PRODUCT CHANGE NOTIFICATION (PCN)

AMJE0909-0700-RDB-24
MODULAR CABLE

CHANGE NOTIFICATION: PCN 20220509_AMJE0909-0700-RDB-24

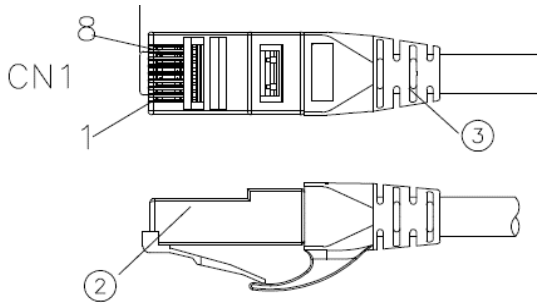
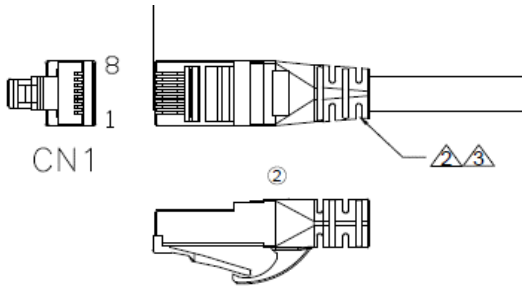
③	Molding	PVC 45P Color: see order code	NA	KG
②	CONNECTOR	RJ45 8P8C two fork Short type 3u" gold plated	2	PCS
①	CABLE	CAT6 UTP (24AWG*1PR)*4+PVC OD=5.8±0.3MM Color: see order code	NA	MM
NO:	NAME	DESCRIPTION	Q'TY	UNIT

3	Molding	PVC 65P Color: see order code ②	NA	KG
2	CONNECTOR	RJ45 8P8C PLUG 3u" gold plated ②	2	PCS
1	CABLE	CAT6 U/UTP (24AWG*1PR)*4+Cross+PVC Jacket OD=5.8± 0.3MM Color: see order code ②	NA	MM
NO:	NAME	DESCRIPTION	Q'TY	UNIT

Drawing-No.
ASS 7945 CA

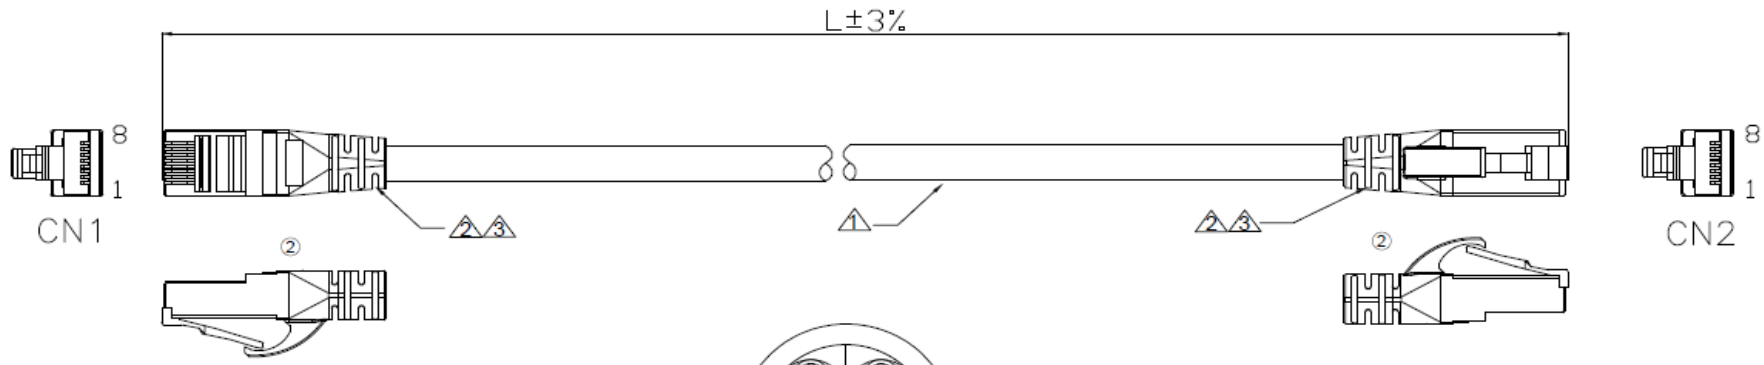
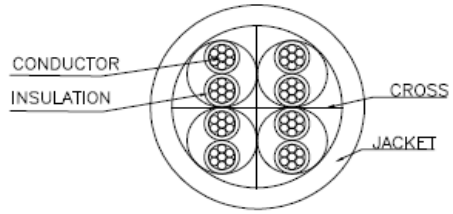
Id.	Modification	Date	Name
②	Change the plant	09.05.2022	Luca
①	Update the WSW order code	02.06.2017	Amy
⓪	Drawn	30.03.2017	Amy

NO:	NAME	DESCRIPTION	Q'TY	UNIT
3	Molding	PVC 65P Color: see order code ②	NA	KG
2	CONNECTOR	RJ45 8P8C PLUG 3u" gold plated ②	2	PCS
1	CABLE	CAT6 U/UTP (24AWG*1PR)*4+Cross+PVC Jacket OD=5.8± 0.3MM Color: see order code ②	NA	MM
